City of Portland, Maine – Building or Use Permit Application 389 Congress Street, 04101, Tel: (207) 874-8703, FAX: 874-8716

DATE: 25 June 97 ADDRESS: 63 Irving St.
REASON FOR PERMIT: Enclose portion of existing deck
BUILDING OWNER: Ernest King
CONTRACTOR: Owner
PERMIT APPLICANT: ↑ APPROVAL: K/x2 x8 ~~DENIED~~

Proposed Use/Work - enclose portion of existing deck

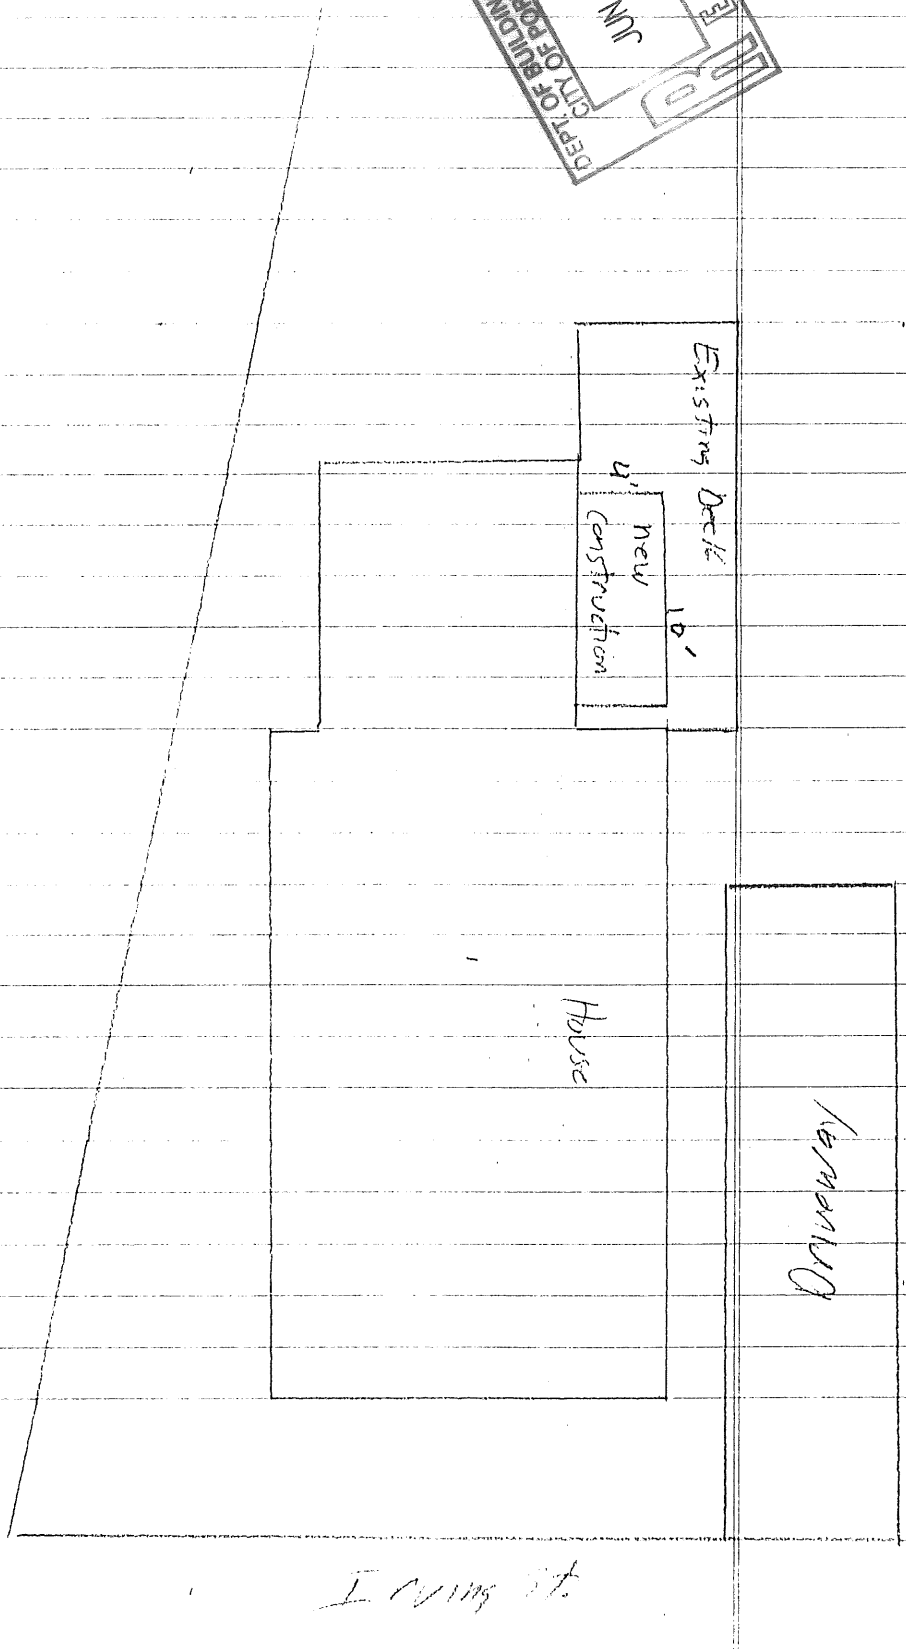
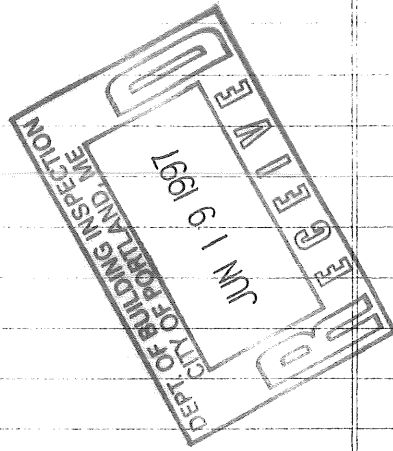
7-7-97 No work yet. Needs foundation plan for load
9-11-97 Framing is partially completed.
10-20-97 Work is all complete.

26. All electrical and plumbing permits must be obtained by a Master Licensed holders of their trade.
27. ~~Your plan does not show the Foundation for the proposed porch enclosure - with the new home and dead loads being placed on the existing deck. A new Foundation plan must be submitted and approved before work begins.~~

I have enclosed a drawing of the foundation for the porch enclosure on my deck. The sonar tubes are 8" and four feet deep, the joist is made of two 2"x6"x12' pressure treated boards, and the new wall is placed directly over the new support beam per our conversation in June. Please note that the drawing is not to scale. If any more information is needed, please call me as soon as possible. Thank you.
